15 Amp, 125 Volt, NEMA L5-15R, 2P, 3W, Single Locking Receptacle, Industrial Grade, Grounding - BLACK

SUBMITTAL IDENTIFICATION SHEET

WEBSTER UNIVERSITY ISB	
PROJECT NAME	
8274 BIG BEND BLVD	
ADDRESS	
NUMBER	
WEBSTER UNIVERSITY	
OWNER	
CANNON DESIGN	
ARCHITECT / ENGINEER	
DEVIN D GATES	
SUBMITTED BY	
123553-001 REV 2	
CONTRACTOR / CM SUBMITTAL NO.	CANNON DESIGN SUBMITTAL NO.
	123553
DRAWING / DETAIL REFERENCE	SPECIFICATION SECTION / PARAGRAPH
MANUFACTURER / SUPPLIER	ITEM / PRODUCT ID
REQUIRED DATE	PRIORITY
	CRITICAL

COPIES	DATE	NO.	DESCRIPTION
1	1/25/17	04437ARI -E2 and 04337BRI -E4	Rough-In & Elevation Shop Drawings
1	1/25/17	04437DETAILS1 & 04437DETAILS2	Cabinet Sections
1	1/25/17	04437OHSC	OHSC detail/quantities Sheet
1	1/25/17	Set	Project Data Document

L5-15R

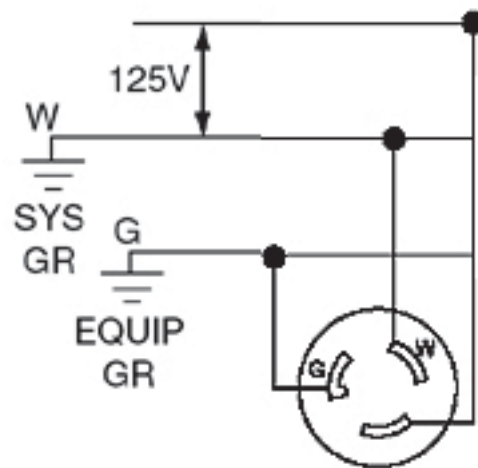
COORDINATE WITH ELECTRICAL
DRAWINGS.

-COORDINATE ALL ELECTRICAL OUTLETS WITH ELECTRICAL DRAWING & SPECIFICATIONS. TECHNICAL SPECIFICATIONS PER ELECTRICAL DRAWINGS.
